**BMP NUMBER:** SC023

## Stormwater Management / BMP Inspection Report

Name of Facility: Walmart PHASE III BMP No.: 4 of 6 Date: 12-2-05

## BMP FINAL INSPECTIONS

POUND I FIELD NOTES

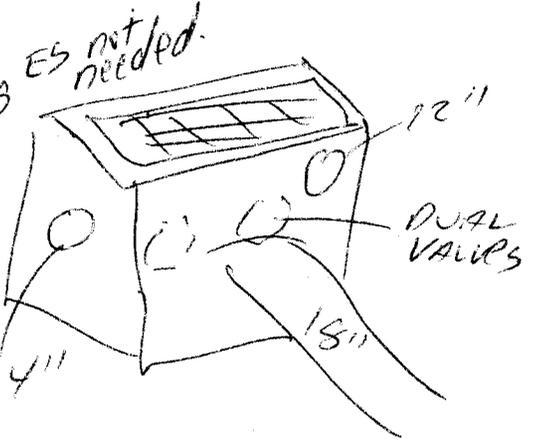
- An emerg spillway not constructed. One is needed at SW corner of dam, at 37.5 w/c I RR.
- need const cert
- need sealed abutts

- Pond well constructed.
- NP a bit lower than LFO due to permeability of pond bottom soils. See letter

DHW 36  
T.O.D. 34  
3' FB
